**NIAGARA FEASIBILITY PHASE 2
NATURAL AND SOCIAL
ENVIRONMENT REPORT**

File No. 161110576

November 2007

**RE: THE REGIONAL MUNICIPALITY OF NIAGARA MASTER PLAN
FEASIBILITY STUDY – RAW WATER FOR AGRICULTURAL
IRRIGATION PURPOSES**

Client/Project
 Niagara Irrigation Study Phase 2
 Natural and Social Environmental Report
 Figure No.
 4
 Title
**Pipe Distribution for West District
 Alternative W1**

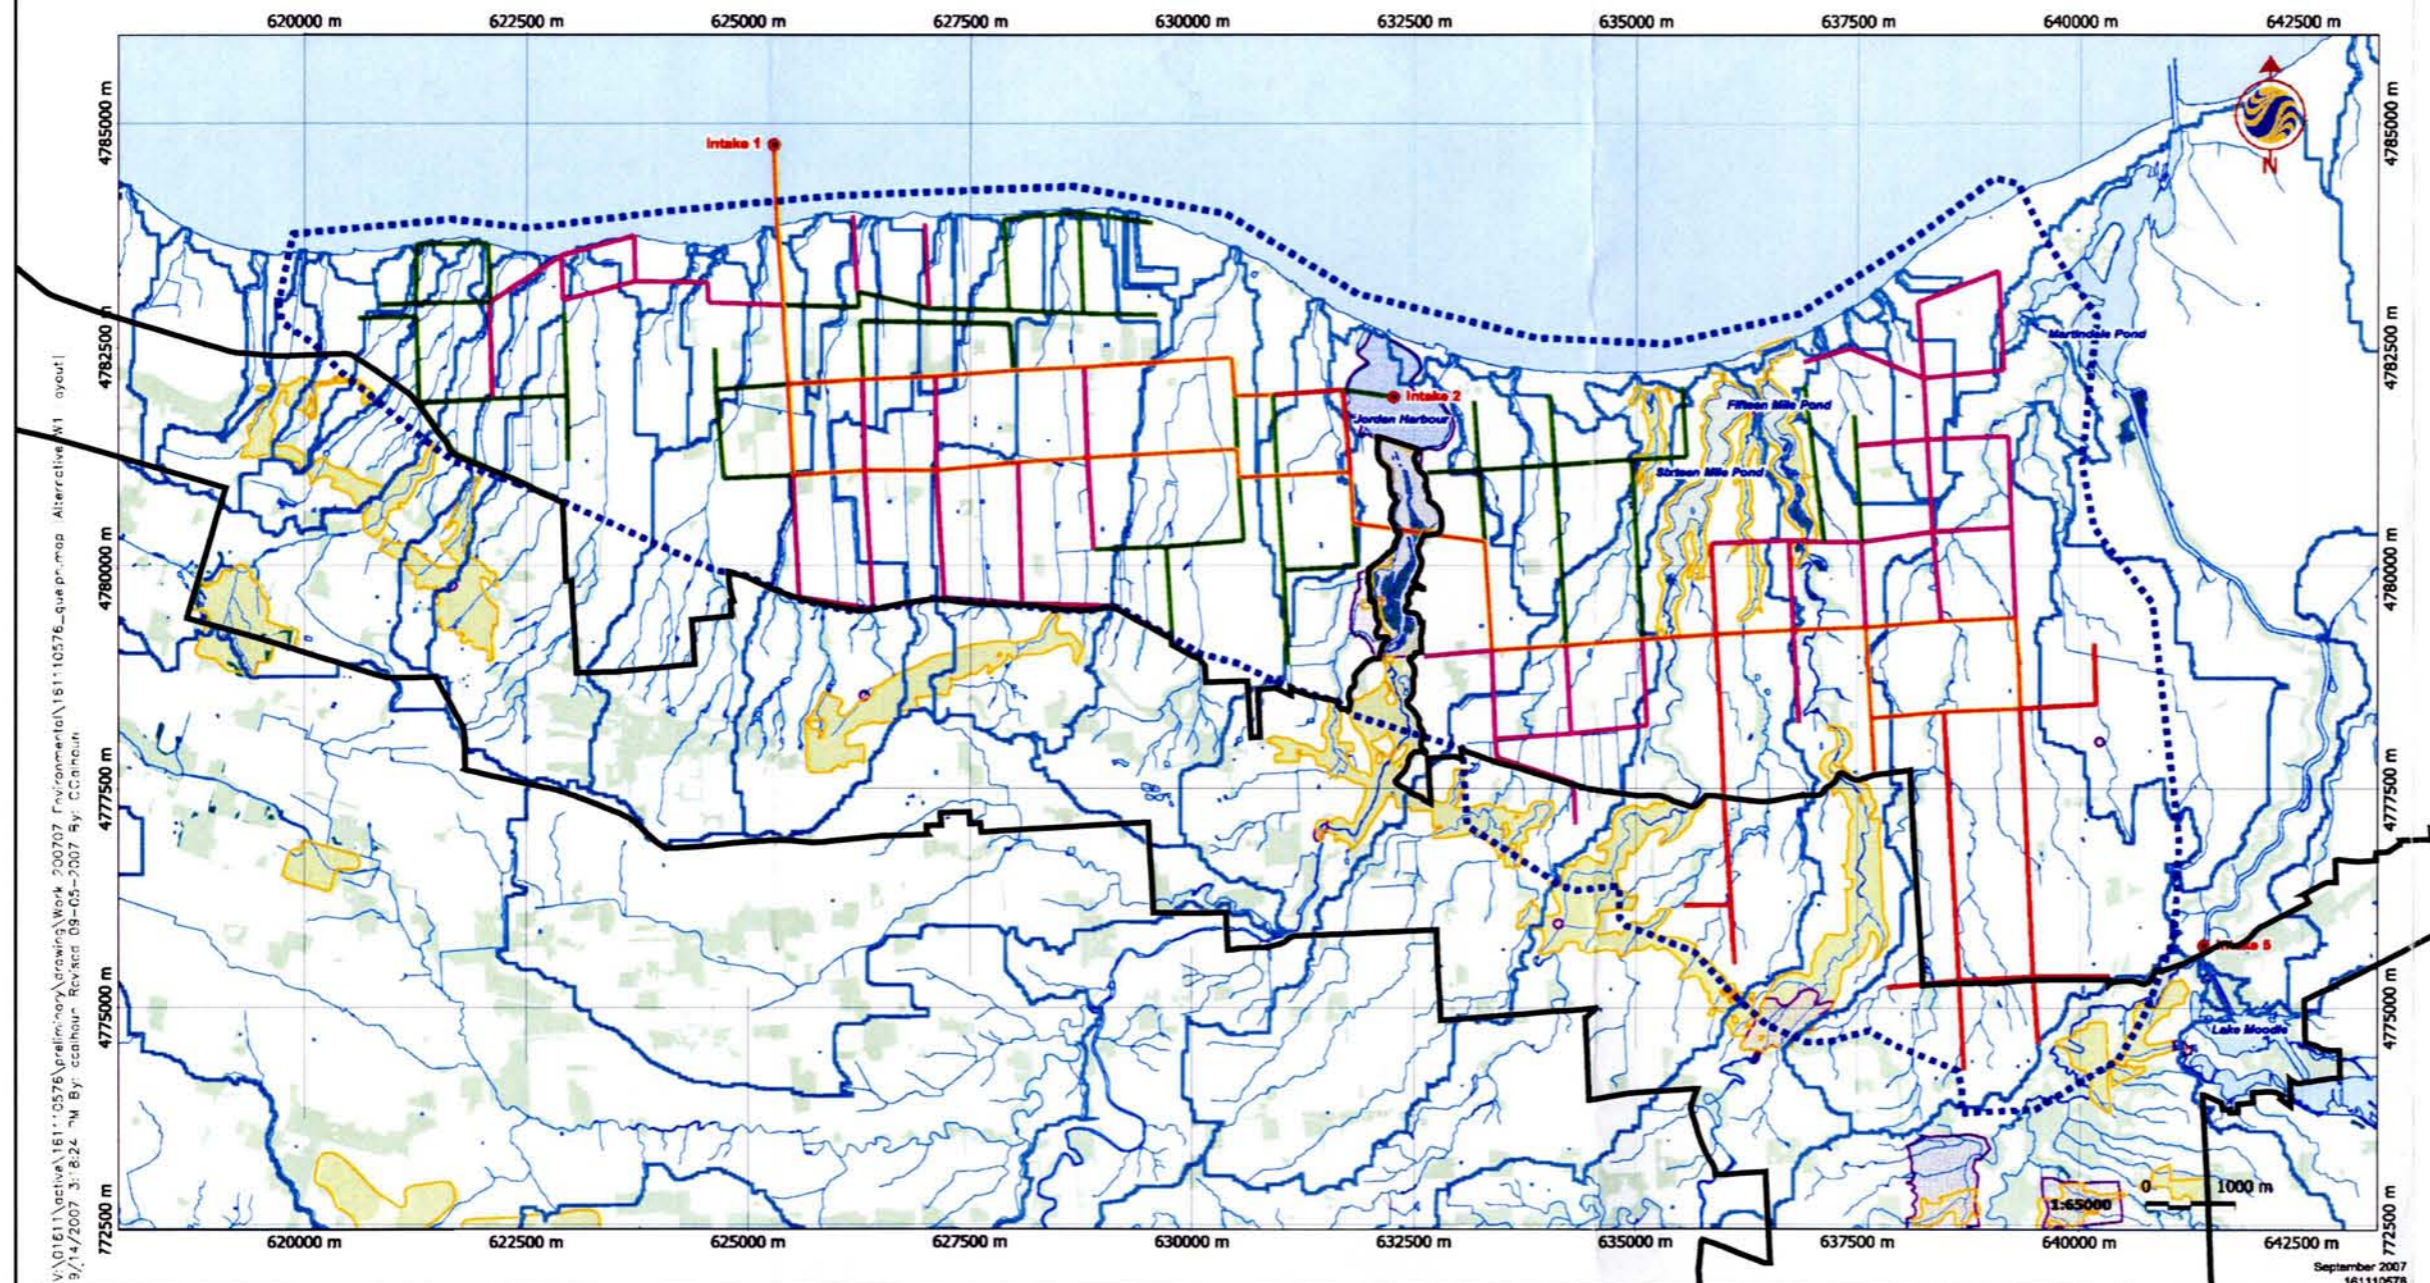
I have included your maps showing the NEP Area for the preferred alternatives. Intake 3 which as I understand, is one of the preferred alternatives of W1 is not shown on Figure 4. Intake 5 is shown on Figure 4 although it is not one of the intakes considered under W1 (See section 1.2.1). The Figures should be modified to highlight the preferred alternative intakes. For the East District – the Figures should all indicate the intake locations.

Thank you for your comments regarding the figures – the figures have been revised to reflect the correct intakes and will be included in the Project Report to be submitted to the Region of Niagara in December 2007.
